Location/Beam	Dimensions	Decay viewed from bearing side	Cross plan view	Photographs		Confirmed agreed repairs with Structural engineer comment in bold
I/VB/1 Bearing end to beam onto VB3 and at mid section				Decay to both bearing end onto the first truss the full depth of the beam, A patch of decay at mid-span 800mm wide x 150mm high to a depth of 60mm. Previous scarf repair 30-40mm deep	 	Recommendations Fully renew the beam with treated timber in two sections 95x175/265mm C24 Douglas fir timber Buro Happold Comment Agreed with beam replacement in email dated 2-12-2024
I/VB/2 Bearing end opposite VB4				Rot to the top corner of the beam opposite VB4. The decay 200mm wide x 175mm in height to a depth of 50mm	 	Recommendations Flitch beam plate repair as per drawings and calculation provided by WMI Consulting Buro Happold Comment Agree with repair in email dated 2-12-24
I/VB/3 Bearing end opposite VB1				Wet rot to bearing end opposite VB1. The decay affected 500mm of bearing end to depth of 40 to 50mm	 	Recommendations Flitch beam plate repair as per drawings and calculation provided by WMI Consulting Buro Happold Comment Agree with repair in email dated 2-12-24

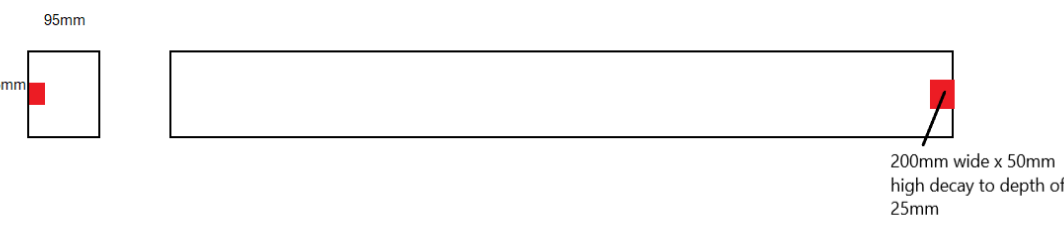
I/VB/4 Bearing end opposite VB2 and full length of beam				Bearing ends opposite VB2 decay depth 50mm , Two metre section decay upper 125mm wide to a depth of 25 to 30mm with white poria growth to surface	 	Recommendations Fully renew the beam with treated timber in using 100x275mm C24 Douglas fir timber Buro Happold Comment Based on BH site inspection further analysis is o be conducted in email 2-12-2024. After investigations agreed with full beam replacement as per email dated 13-12-2024
I/VB/5 Bearing end opposite VB3 and full length of beam				Wet rot to the bearing end opposite VB 3 rot 30mm deep to section 800mmx125mm Further decay to a 3metres by 125mm to a depth between 25 to 30mm	 	Recommendations Fully renew the beam with treated timber in using 100x275mm C24 Douglas fir timber Buro Happold Comment Based on BH site inspection further analysis is o be conducted in email 2-12-2024. After investigations agreed with full beam replacement as per email dated 13-12-2024

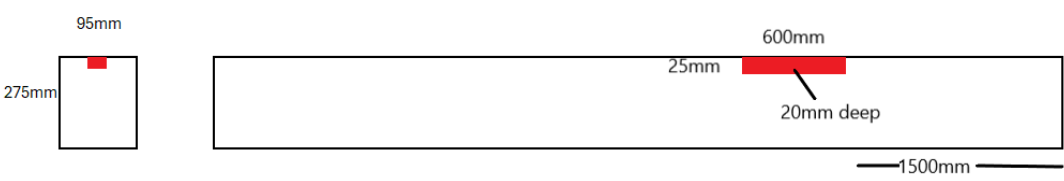
I/VB/6 Bearing end opposite VB4				Wet rot to top corner of the beam 300mm wide x 100mm to depth of 20mm		Recommendations Defrass the beam end back to sound timber and treat with Probor 20 fungicide gel Buro Happold Comment Agree with repair as per standard noted as per email dated 2-12-2024

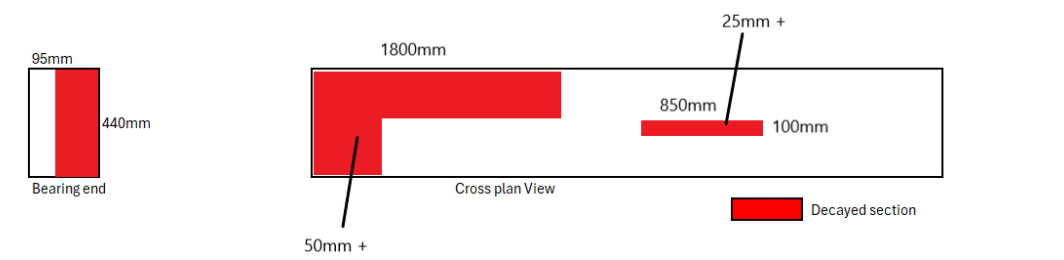
I/VB/7 Bearing end opposite VB5		Pocket of rot 75mm deep 100x100mm in section Further pocket of rot to top edge 30mm deep 300x30mm in section			Recommendations Flitch beam plate repair as per drawings and calculation provided by WMI Consulting Buro Happold Comment Agree with repair to encapsulate both repair location as per email 2-12-2024
I/VB/9 Bearing end opposite VB7					Recommendations De-frass the decay back to sound timber and splice a new section wedge shaped glue with Sikadur 31 EF 2 Part Epoxy Structural adhesive Buro Happold Comment Agree with repair as per standard noted as per email dated 2-12-2024
I/VB/12 Mid section of the beam		1500mm from bearing end 600mm wide patch of rot 25mm in height to depth of 20mm			Recommendations De-frass the decay back to sound timber and splice a new section wedge shaped glue with Sikadur 31 EF 2 Part Epoxy Structural adhesive Buro Happold Comment Agree with repair as per standard noted as per email dated 2-12-2024

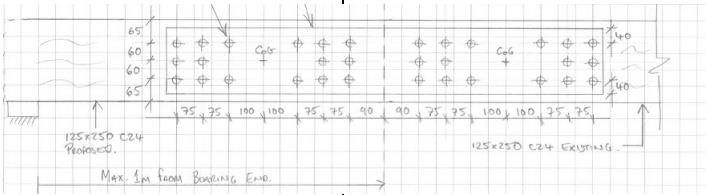
I/VB/13 Full length of the beam		Rot to the inner face to the valley The first 2 metres from the external wall the decay 30 to 50mm to the upper 175mm of exposed beam. Superficial decay to the remaining 3 metres 10 to 15mm deep to upper 175mm of beam			Recommendations Fully renew the beam with treated timber in two sections 95x175/265mm C24 Douglas fir timber Buro Happold Comment Agree with replacement to be like for like as per email dated 2-12-2024
Purlin end Full length of the beam	 Decayed purlin end identified in previous reports between Gridlines H and I to elevation facing Power Ro. Confirm decayed to bearing within brickwork.		 WLM Purlin repair		Recommendations Currently fixed with 2 steel brackets, propose to cut decayed section out of brickwork and support on steel shoe resin bolted to brickwork. No repair required to timber Buro Happold Comment Agree with replacement BH to provide loads . Timber end in the wall to be cut and end Repair to be flitch plate/paated splice as per email dated 2-12-24. RPL designs provided approved in email dated 17-1-2025 from BH

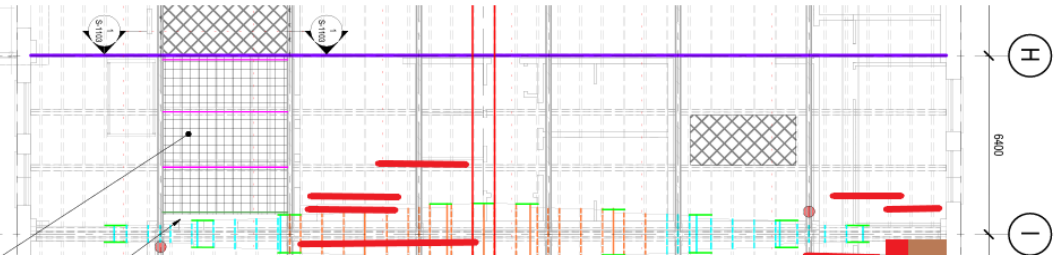
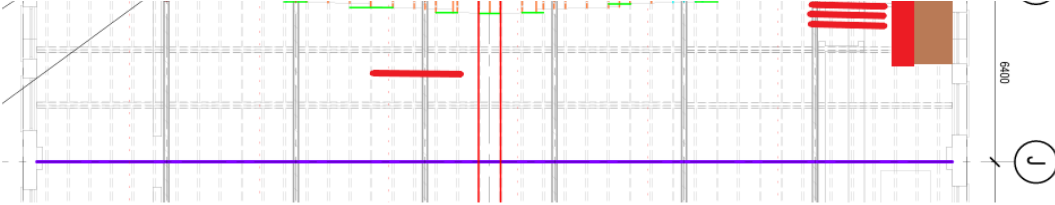
Sarking board					 Recommendations Renew with Redwood 19x225mm boards

Hatch to be removed by others Areas of sarking board renewal	   BH Comment	<u>Robinsons to replace all decayed sarking boards like for like as per email dated 2-12-2024</u>
--	--	--	--
